SERVICE LETTER

No. 707

Subject: Modified Flyball Assembly to Improve RPM Control
-- reference attached Hartzell Service Letter No. 75,
dated November 16, 1973.

SERVICE LETTER NO. 75

A-153(A)-(C) FLYWEIGHT (SEE CHART)
(MATERIAL GROUND FROM
SIDES ON "A" MODIFICATION)

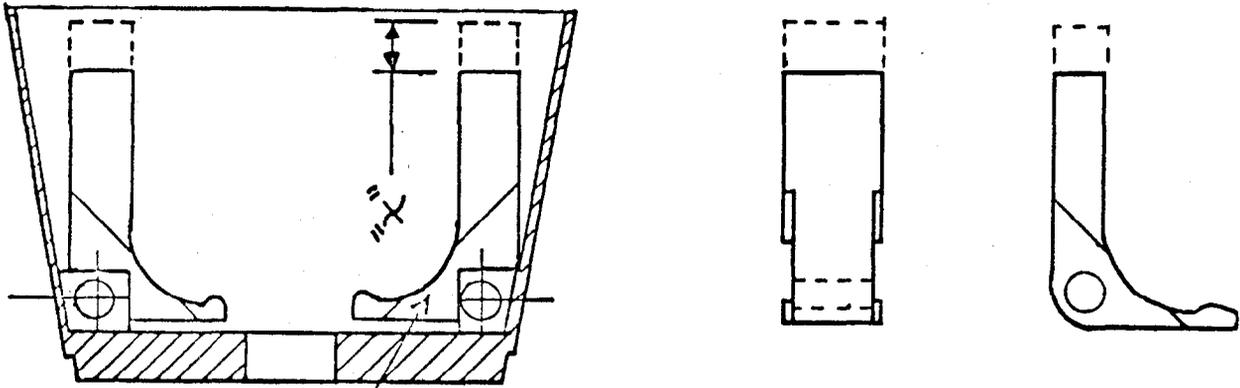
Discussion: To effect an improved RPM control on aircraft with the Hartzell governors, a modified flyweight assembly designed to absorb the torsional motions of the drive gear are being installed in all Hartzell production governors.

- 1) Governors now in the field which are not providing acceptable RPM control may be returned to the factory for exchange. All governors will be brought up to date at overhaul.
- 2) Governors may be modified in the field.

- 1) Determine flyweight assembly needed using parts listed in this letter.
- 2) The flyweight assembly can be changed by:
 - a) removing cover assembly
 - b) removing flyweight assembly locking ring
 - c) removing flyweight assembly
 - d) placing new flyweight assembly in place
 - e) replacing lock ring, making sure it is in place
 - f) replacing cover gasket 50672, and
 - g) installing cover assembly

A-153A-2	0	1600-2800
A-153A-1	.250	2500-3700
A-153A	.462	3200-4350
A-153-2	0	1600-2800
A-153-1	.250	2500-3700
A-153	.462	3200-4350
PART NO.	X" LENGTH REMOVED	RPM. RANGE
